NEW YORK HARBOR
CHANNEL NAVIGATION IMPROVEMENT 50 FT PROJECT
AMBROSE CHANNEL

CONTRACT2
S–AM–1
W912DS–05–B–0012

Symbol	Description	Date	App.
A	Revised Plan sheets No.3,4,5,6,8,9,10,11,12 and cross sections sheet No.13,14 and15	8/8/05	G.A.
B	Sheet C-33 and C-34 are eliminated and sheet numbers are renumbered accordingly 1 thru 35, and Alignment Data sheet All Plan Sheets and Cross sections sheets are revised.	7/19/05	G.A.

COVER SHEET,GENERAL PLAN AND INDEX TO DRAWINGS

PLAN SHEET STA.-24+248 TO STA.4+626

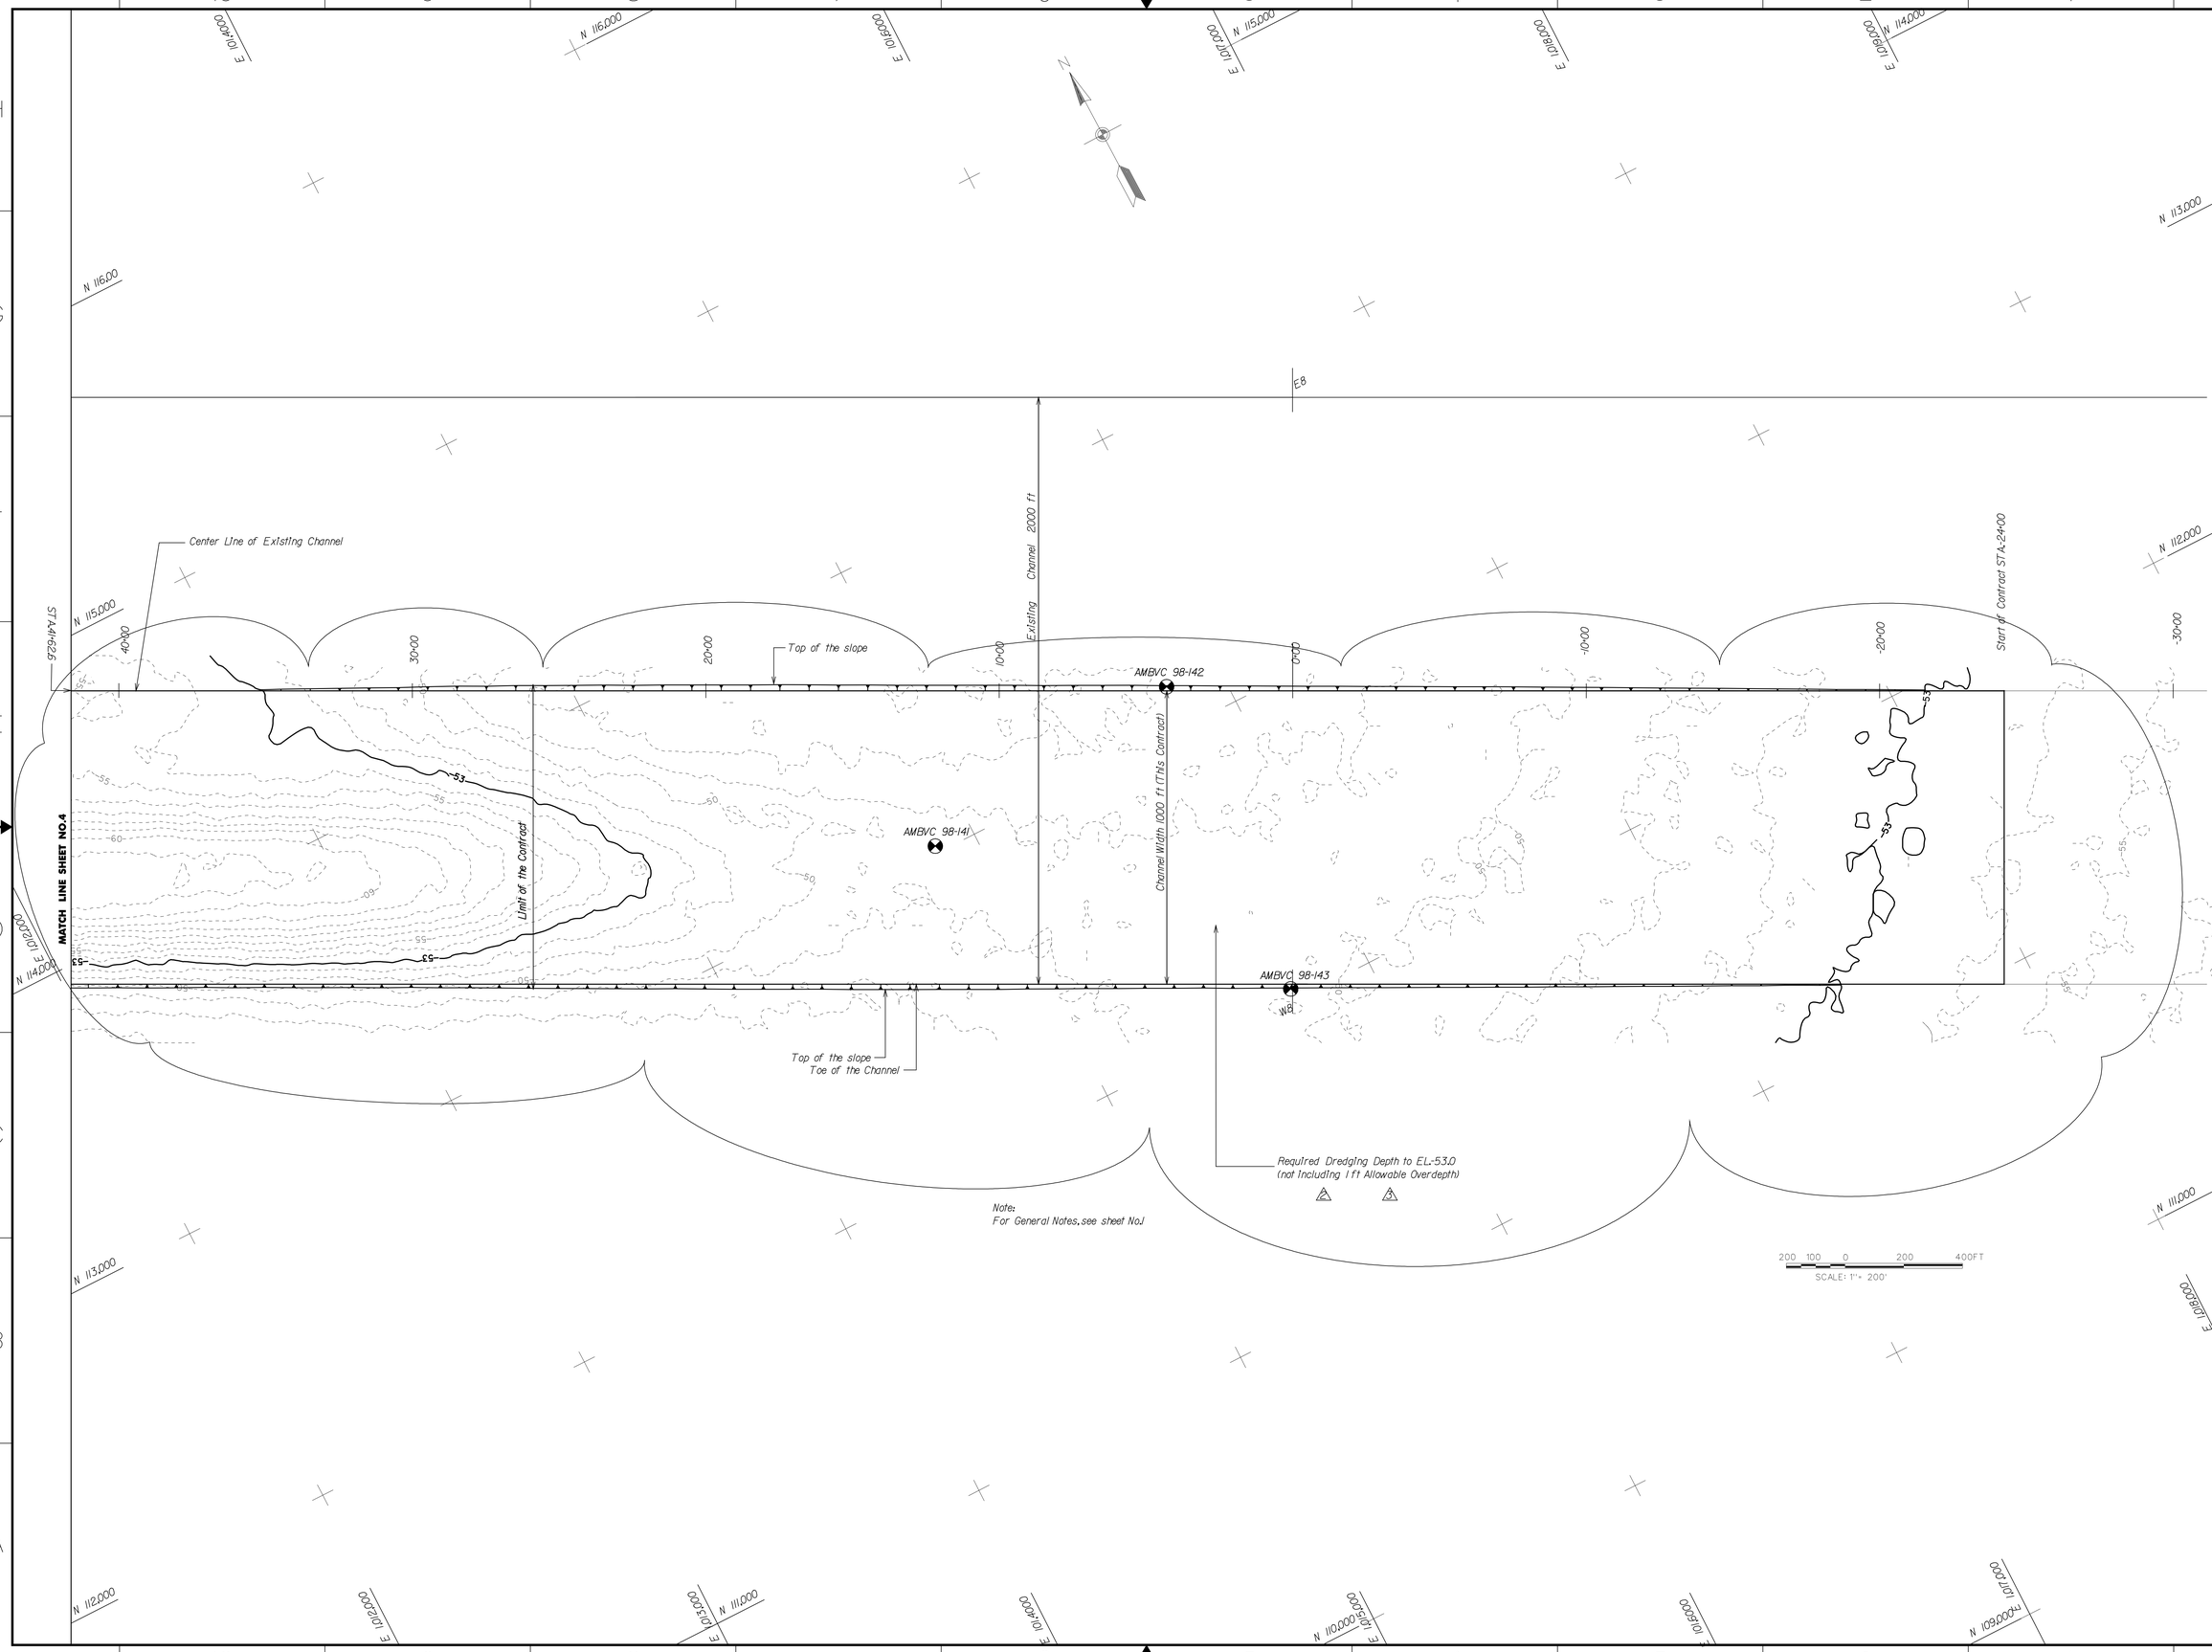
Symbol	Description	Date	Appr.
2	Replaced Allowable overdepth and side slope	2/8/05	G.A.
1	Replaced Allowable overdepth	1/19/05	G.A.

PLAN SHEET STA183+90 TO STA255+03.8

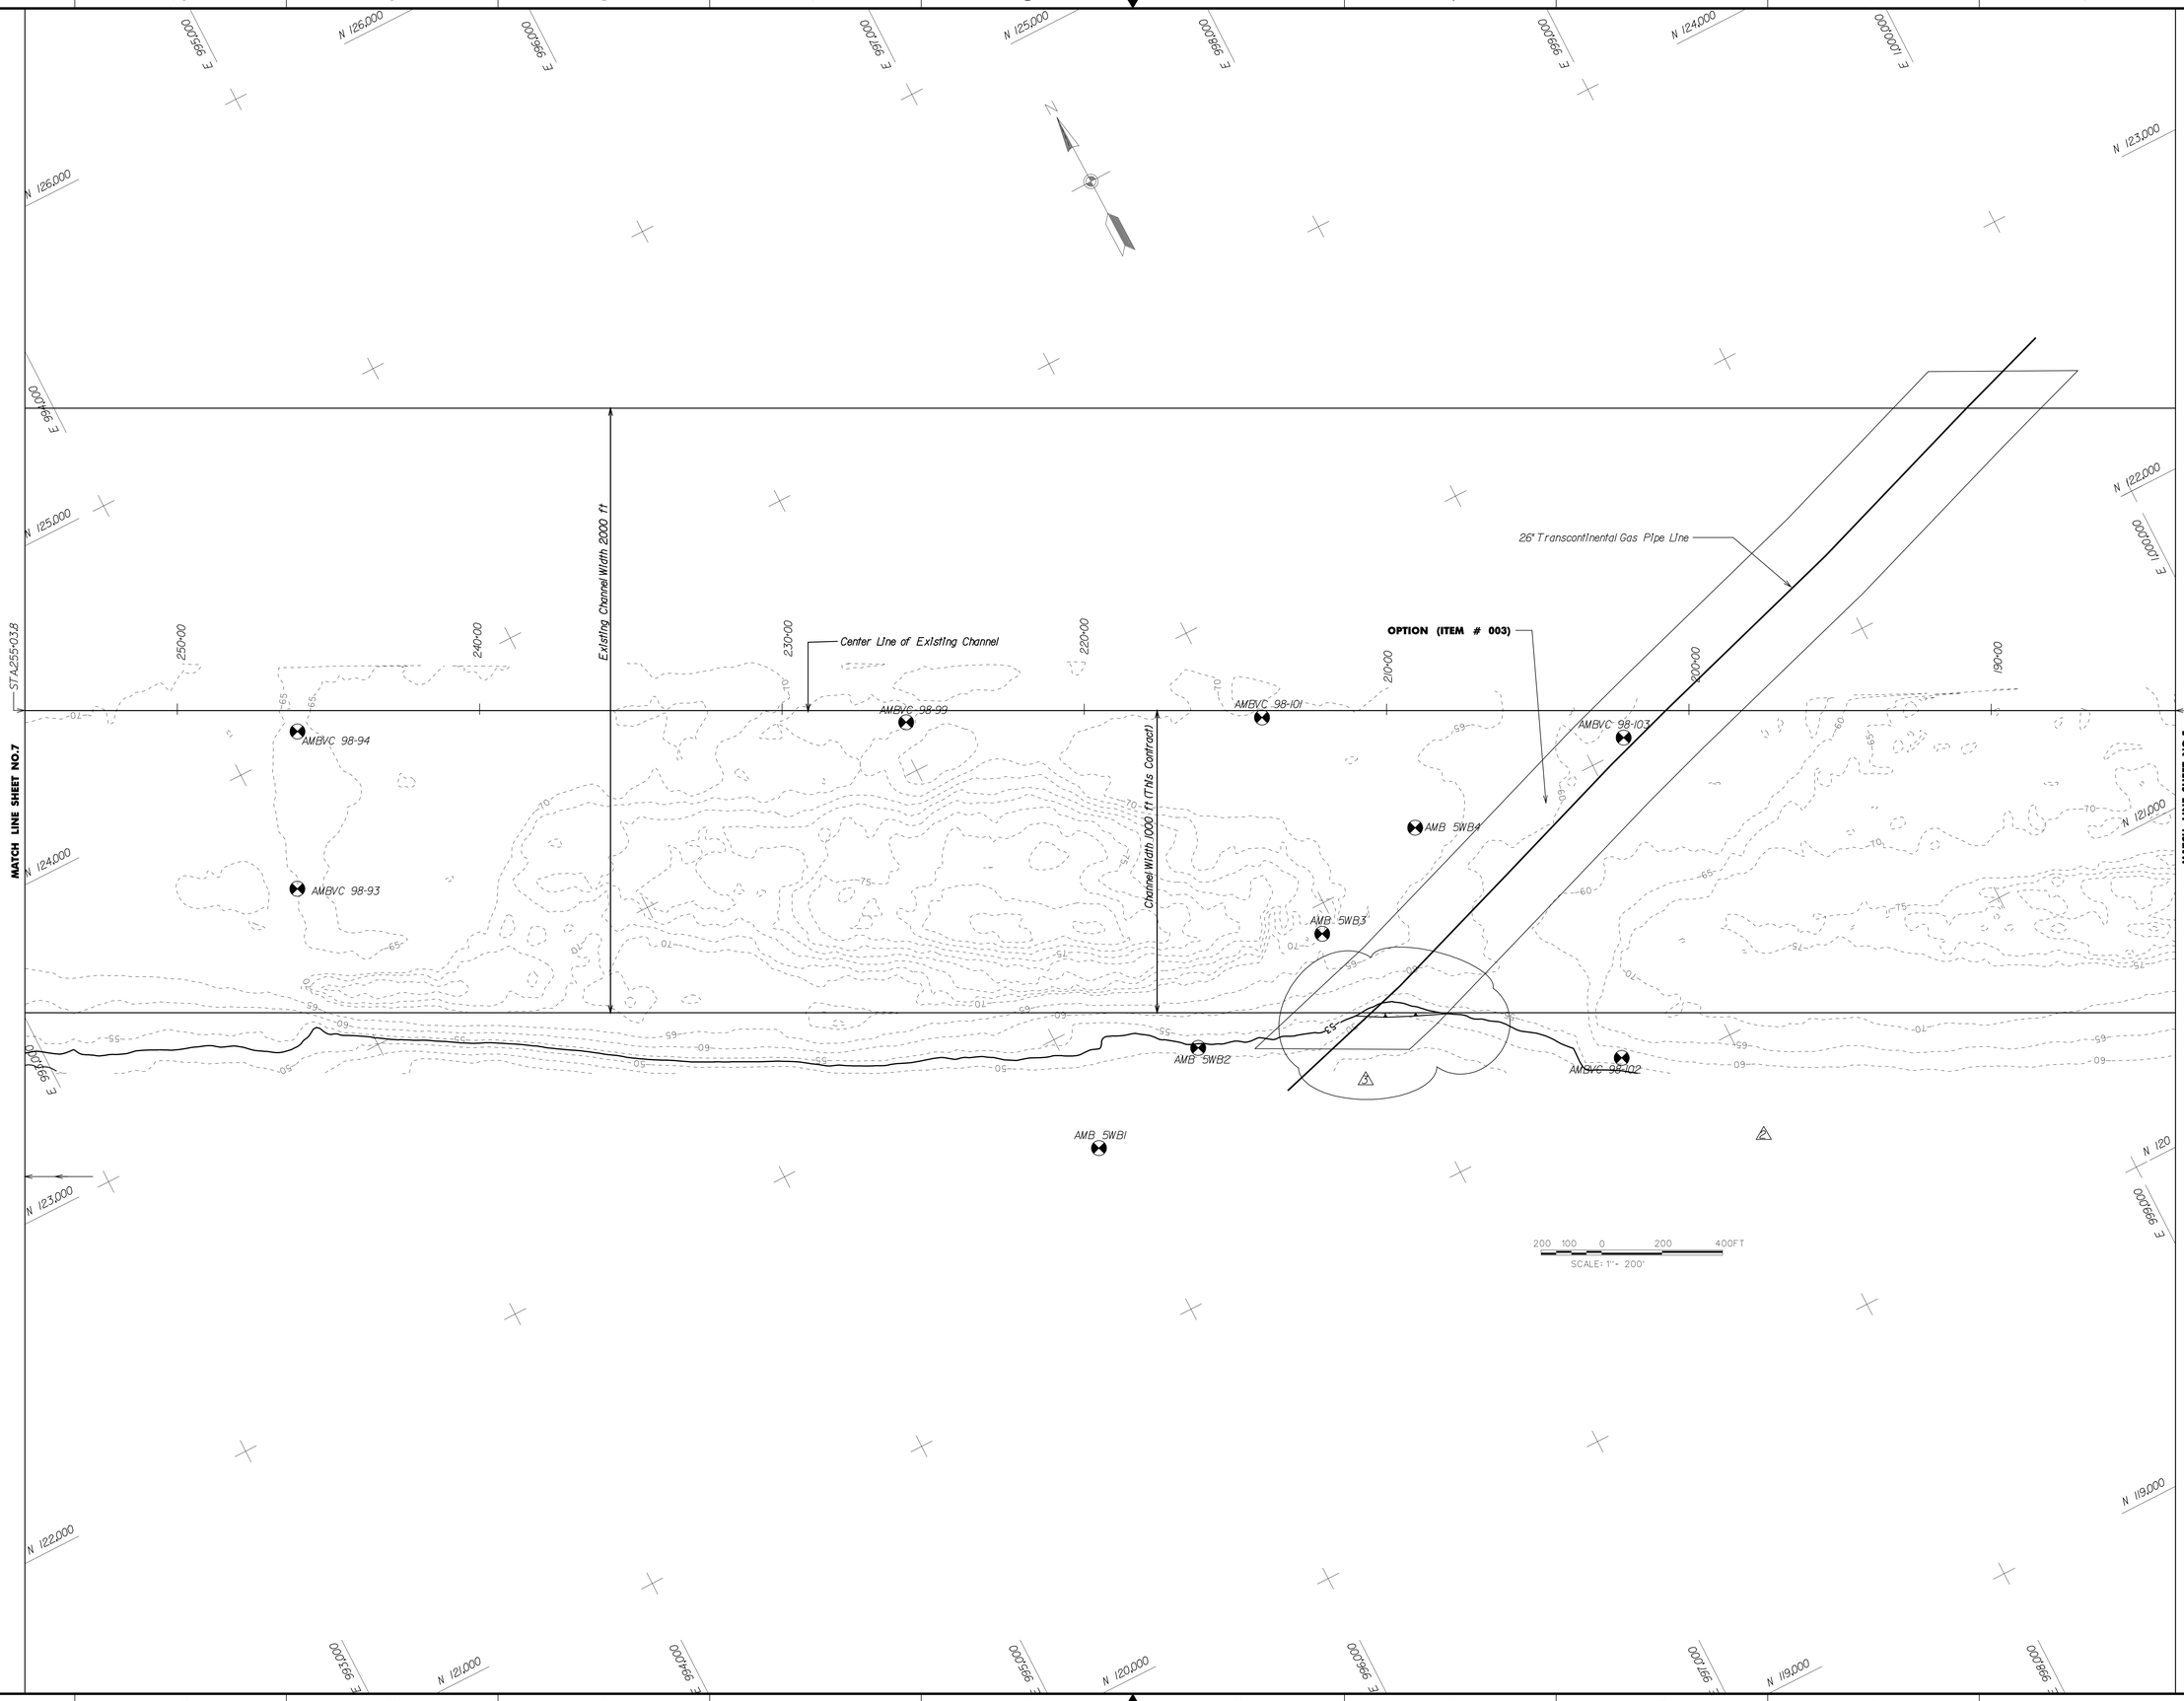
Symbol	Description	Date	Appr.
2	Revised Allowable Overdepth and Required Dredging Depth This area is deeper than Required Dredging Depth including 1 ft allowable overdepth	8/18/05	G.A.
1	Revised Allowable Overdepth	7/19/04	G.A.

PLAN SHEET STA326+17.7 TO STA397+55

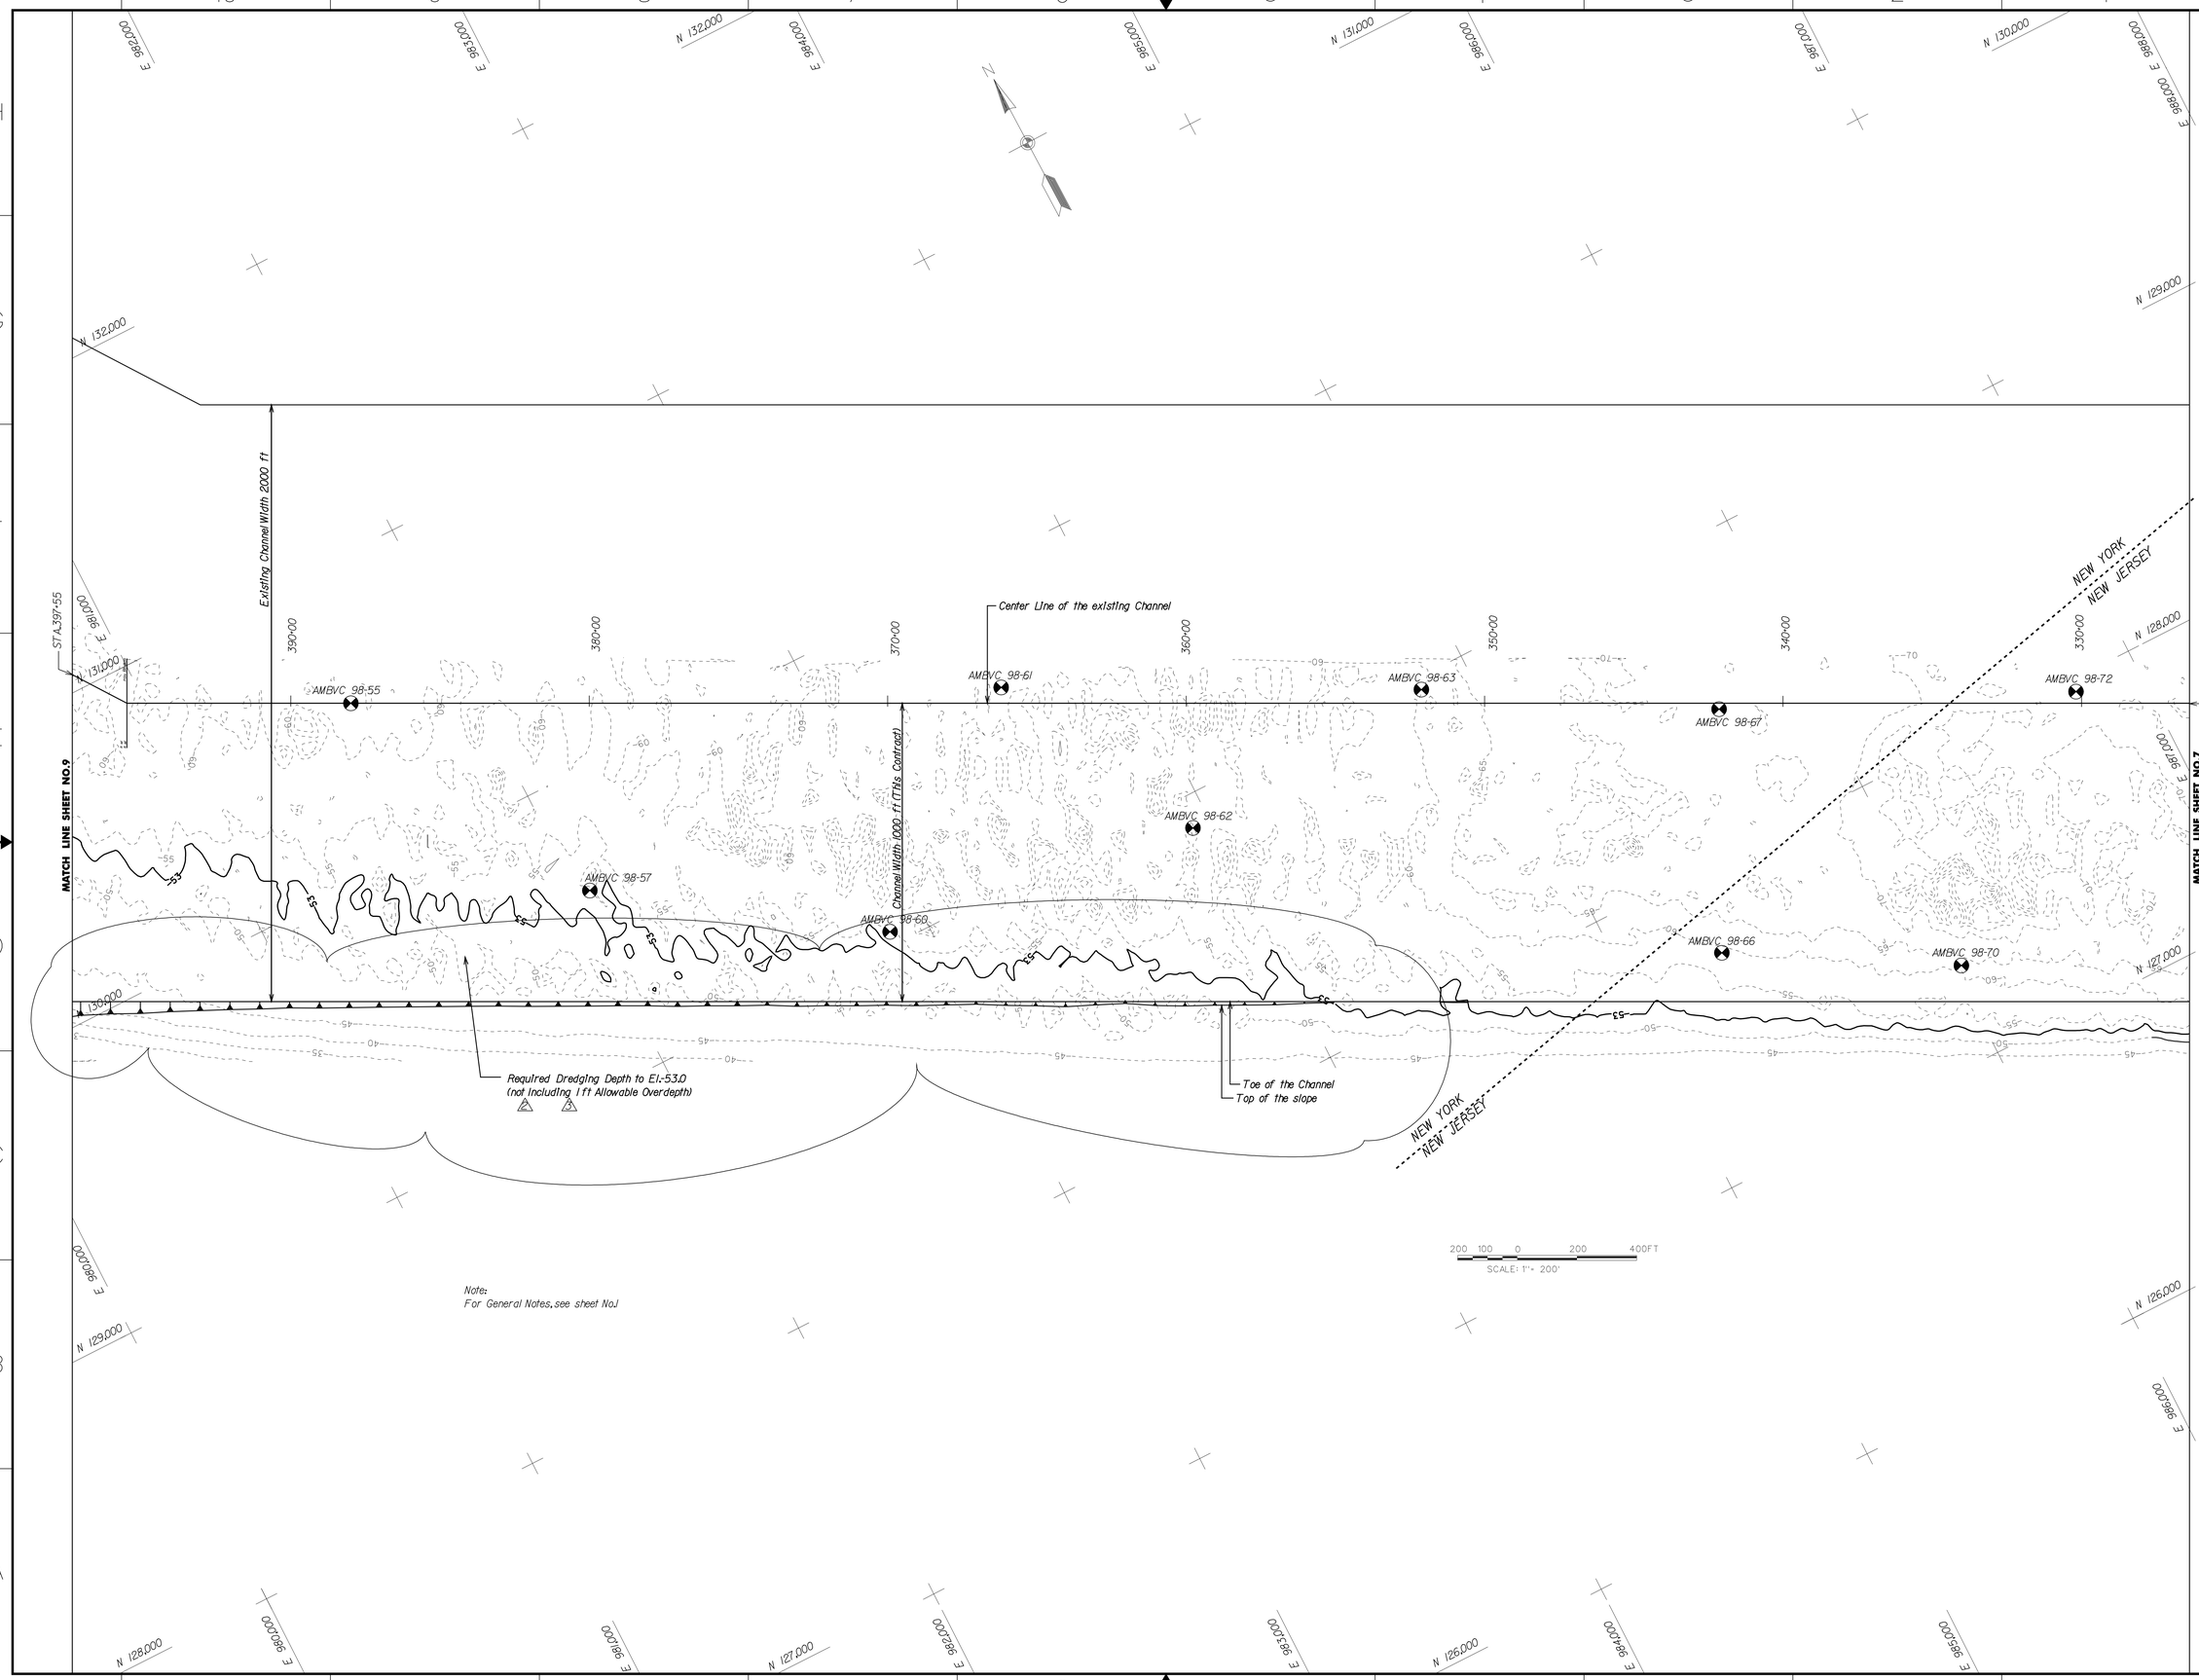
Rev.	Description	Date	Appr.
2	Revised Allowable Overdepth and side slope	8/8/05	G.A.
1	Revised Allowable Overdepth	7/19/05	G.A.
